# PLATTE SELF STORAGE

## GRADING AND EROSION CONTROL PLAN

### OVERVIEW SHEET

AUGUST 2024

**ACCESS ROAD - PLAN & PROFILE**  
 HORZ SCALE: 1"=40' - VERT SCALE: 1"=4'

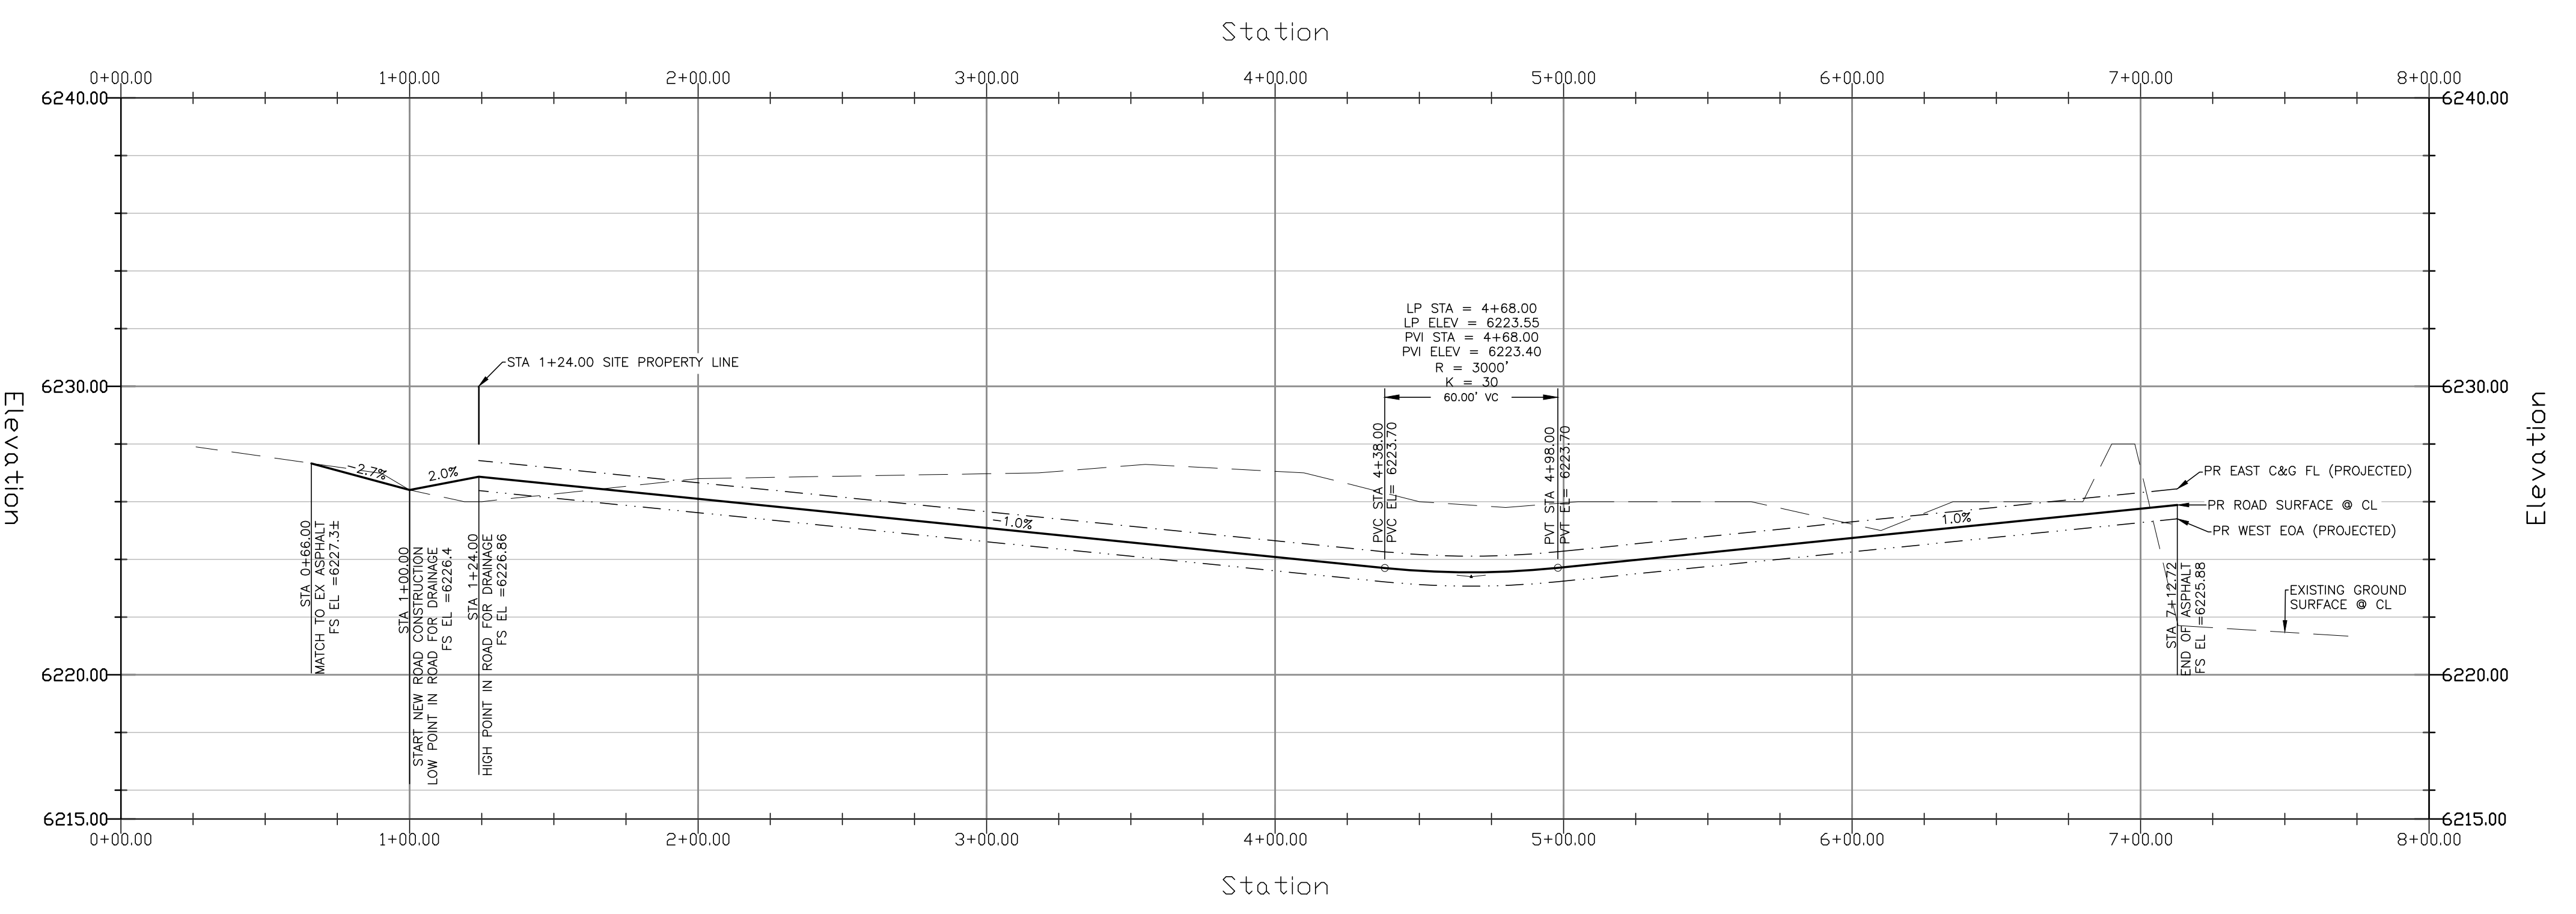
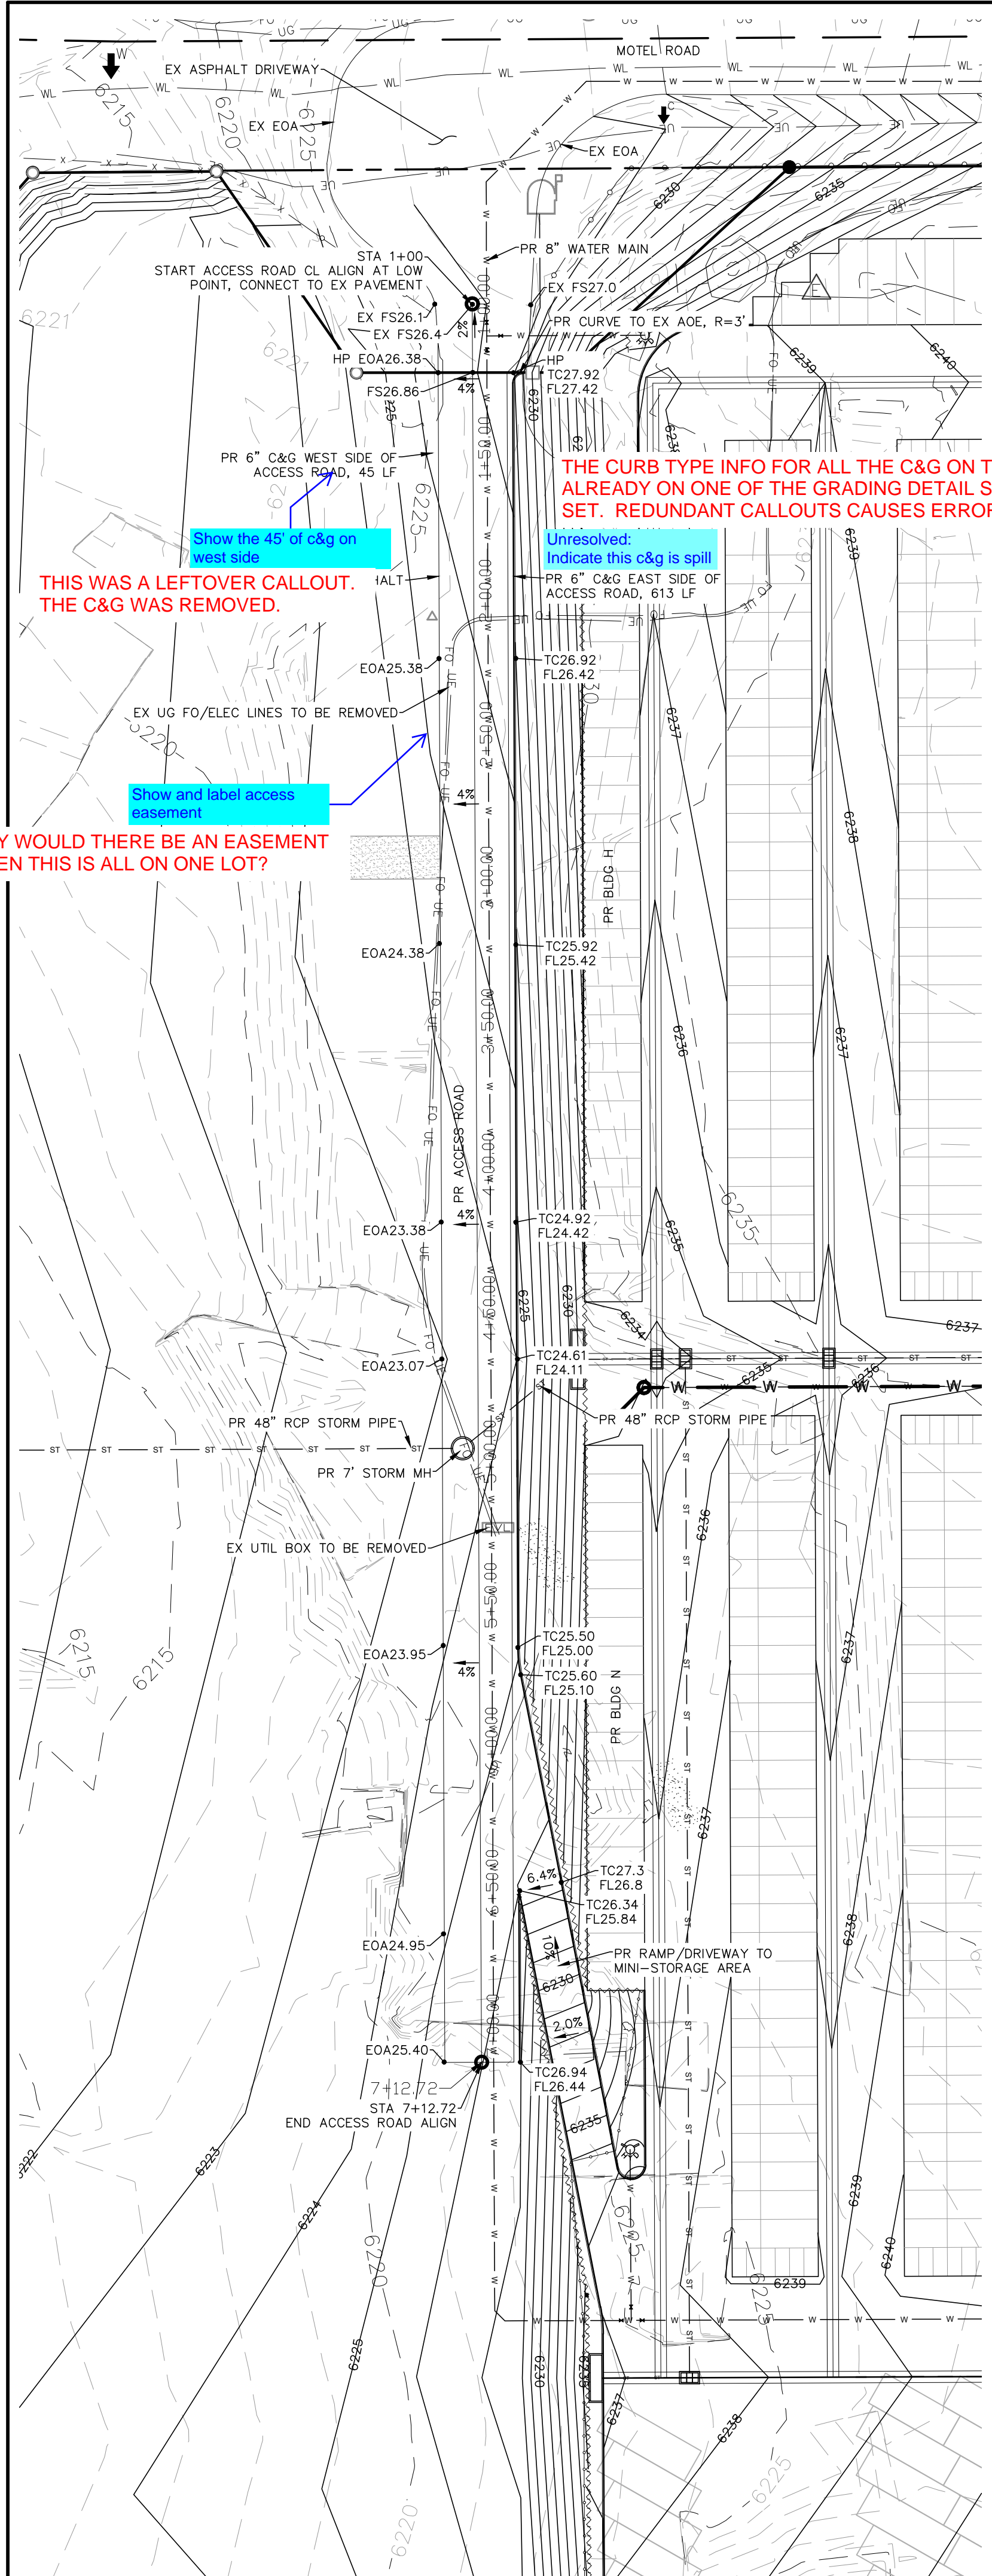
Show the 45' of c&g on west side  
 THIS WAS A LEFTOVER CALLOUT. THE C&G WAS REMOVED.

Show and label access easement  
 WHY WOULD THERE BE AN EASEMENT WHEN THIS IS ALL ON ONE LOT?

Unresolved: Indicate this c&g is spill  
 THE CURB TYPE INFO FOR ALL THE C&G ON THE PROJECT IS ALREADY ON ONE OF THE GRADING DETAIL SHEETS IN THIS PLAN SET. REDUNDANT CALLOUTS CAUSES ERRORS.
